RE: Amendment to Application of Logos Broadcasting Corporation for a New Noncommercial FM Station on

Channel 2075, to Serve San Luis Obispo, California

(BPED-910219MJ)

ENGINEERING STATEMENT IN SUPPORT OF AN

Vertical Sketch
Logos Broadcasting Corporation
Amendment To Application For CP
File #BPED-910219MJ
FM Channel 207B
San Luis Obispo, CA

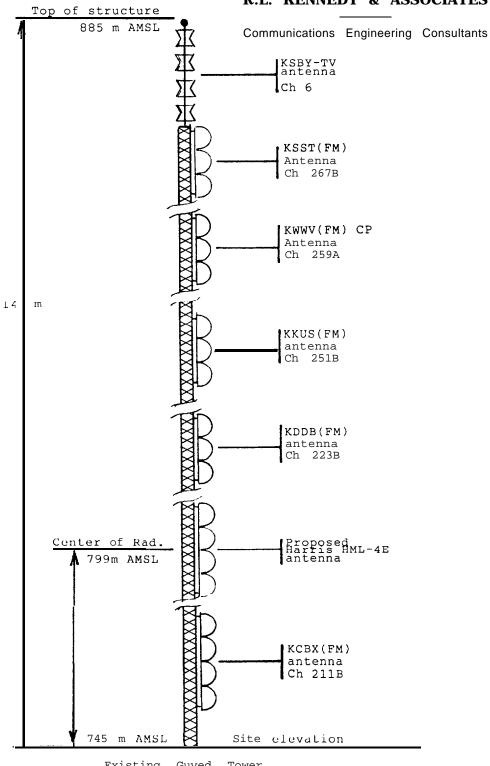
By the instant amendment, Logos is changing the proposed height above average terrain (HAAT) to 466 meters and the effective radiated power (ERP) to 4.4 kW both horizontally and vertically polarized in order to reflect the new conditions. The transmission system is unchanged except for a reduction of 34 meters in the length of the transmission line and an appropriate increase in the transmitter power output to maintain an equivalent Class B facility. Since the original application and this amendment both propose equivalent Class B facilities from the same geographic location, the area within the predicted 1mV/m service contour and the number of persons residing therein are virtually unchanged. Therefore, this amendment does not represent a major change as defined in 47 CFR Section 73.3573.

Elevation of site AMSL	745.2	m
Overall elevation of supporting structure	139. 9	m
Overall elevation AMSL	885. 1	m
Elevation of average terrain AMSL	332.8	m
Elevation of radiation center above site	53.3	m
Elevation of radiation center AMSL	798.5	m
Elevation of radiation center AAT	465.7	m
